**RE: Mandalong Mine MOD 5 – Response to Additional Information Request**

### Mandalong Mine MOD 5 - Response to Additional Information Request

**FIGURE 35**  
**Potential Remnant Ponding and Observation Points**  
**Longwalls 18 to 24a**

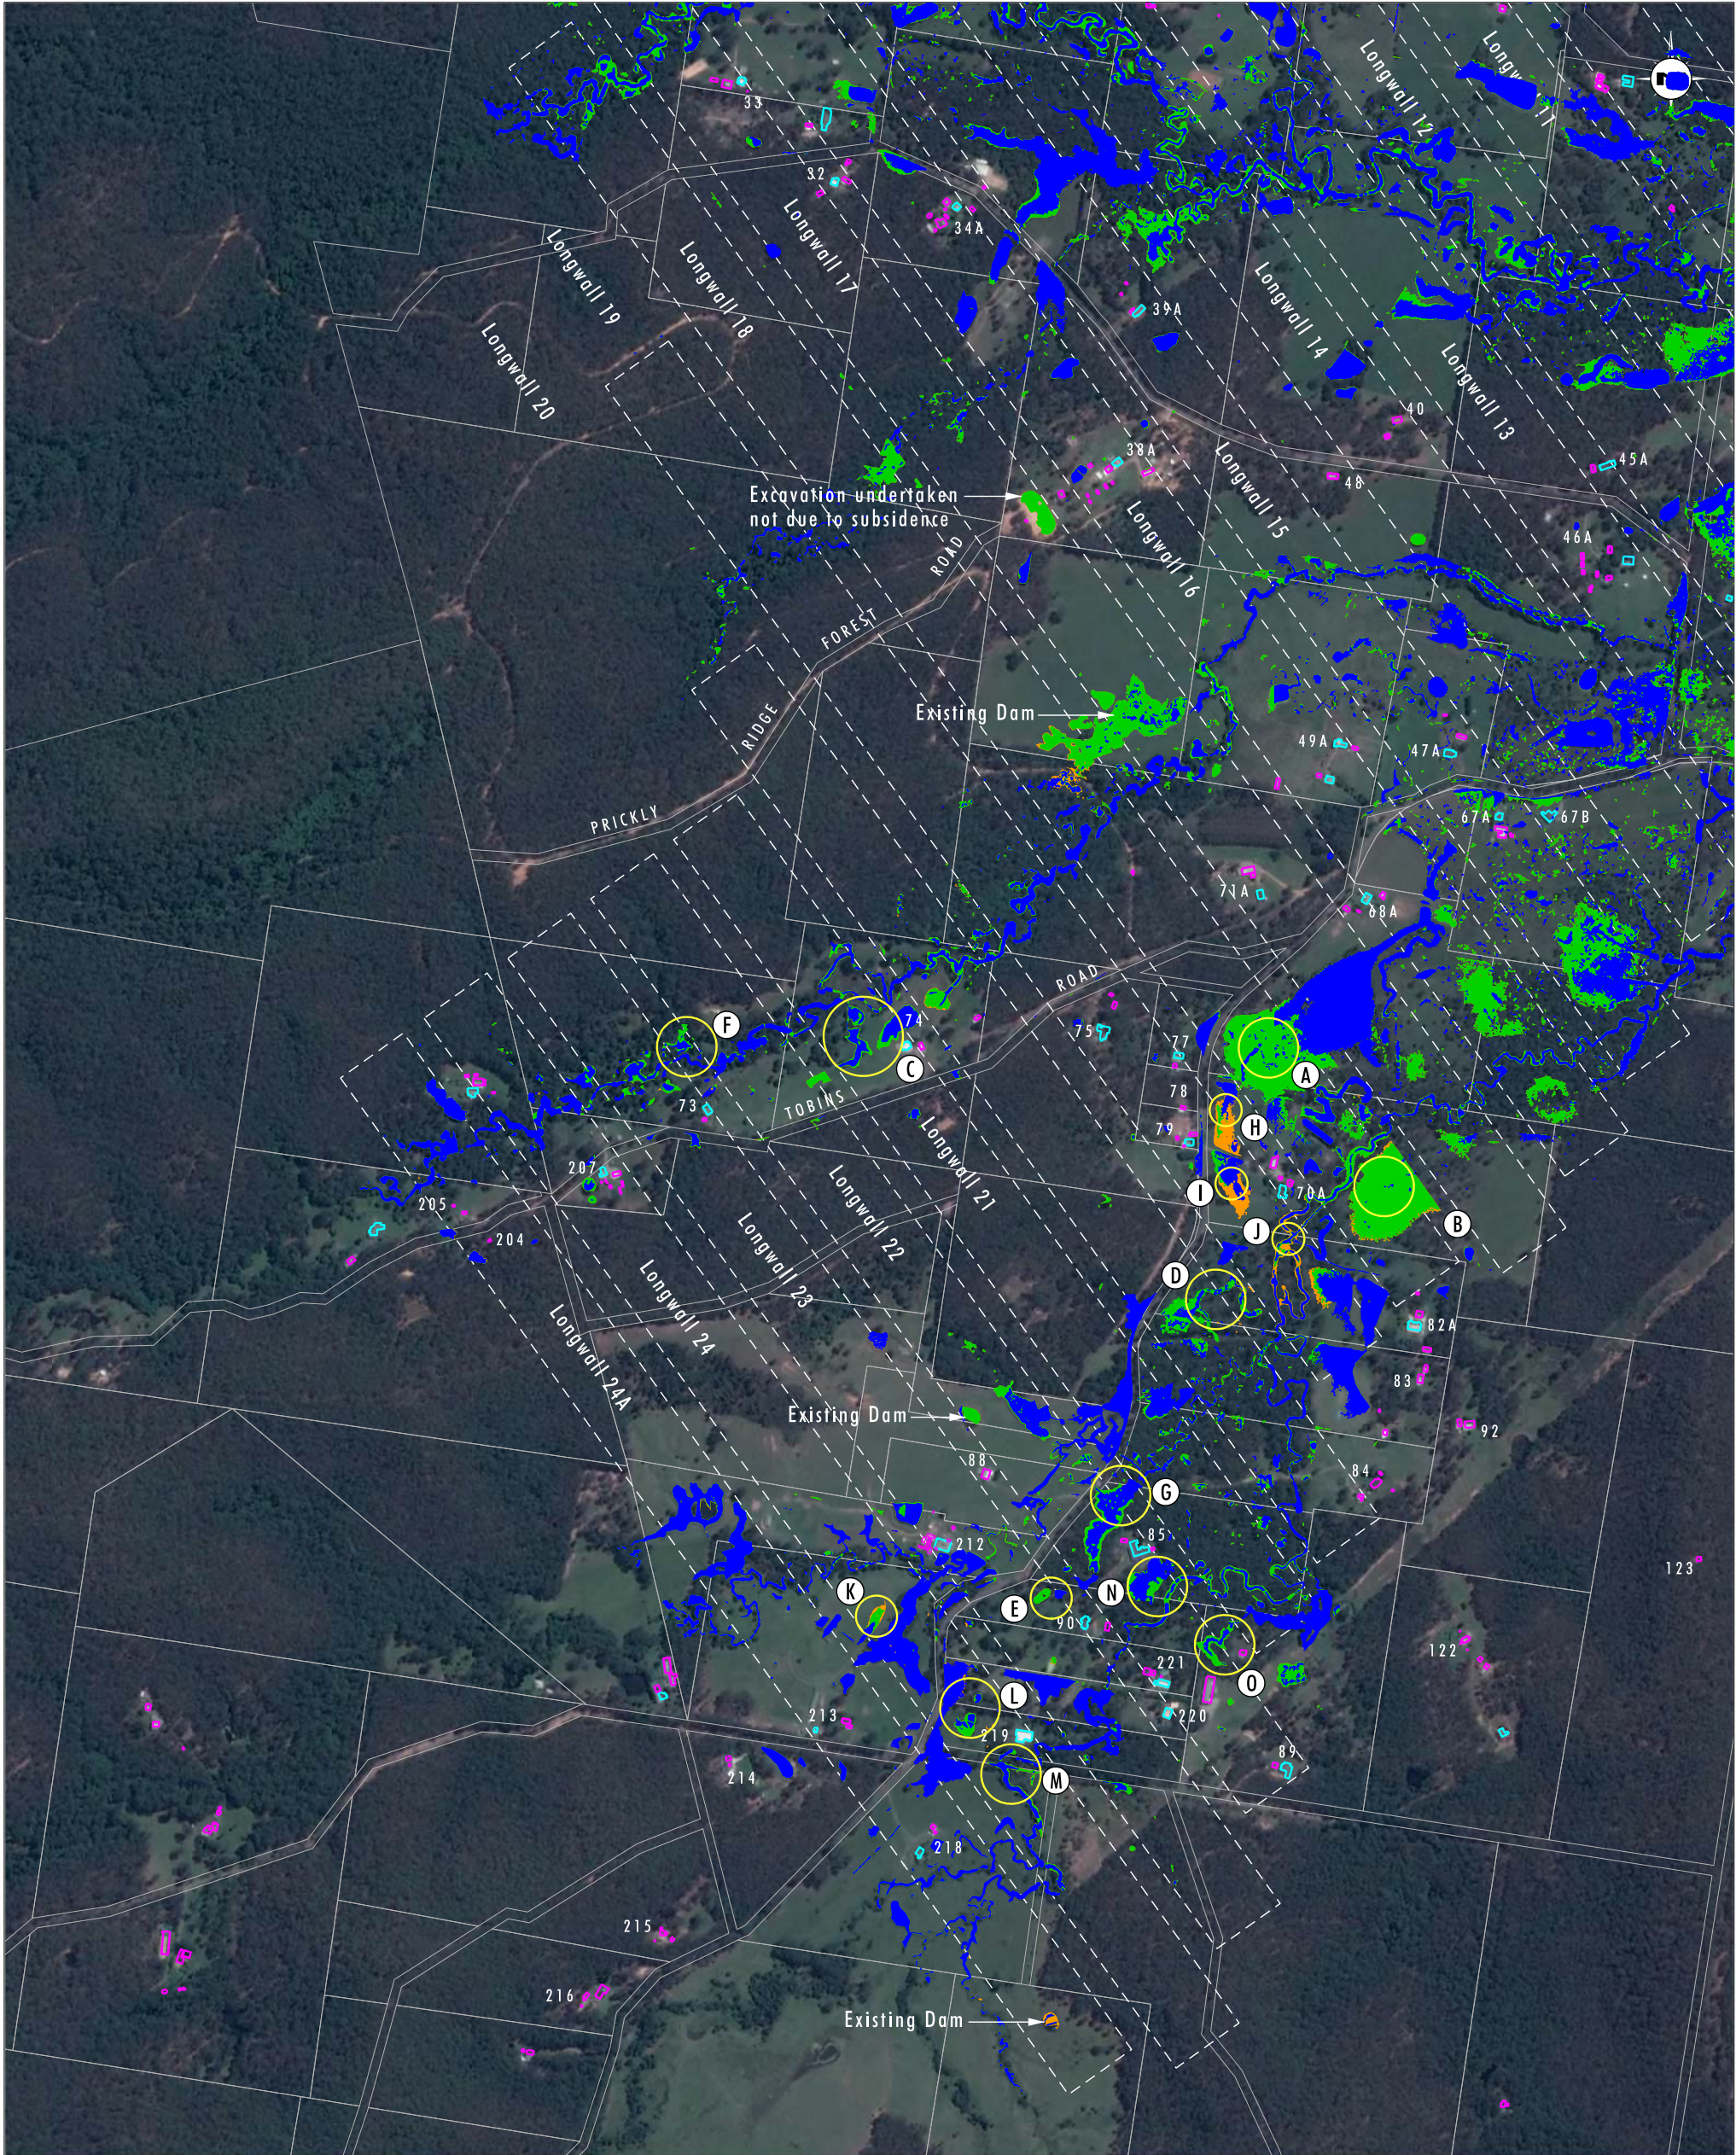
**Issue:** *Error in Figure 35 of the Flood Assessment Report. The legend shows that predicted ponding for MOD 5 is shown in green. The 'approved' and 'proposed' colours have been switched. Request a revised Figure 35 to be provided.*

**Response:** A revised Figure 35 from the Flood Assessment Report (Umwelt 2017) has been attached.
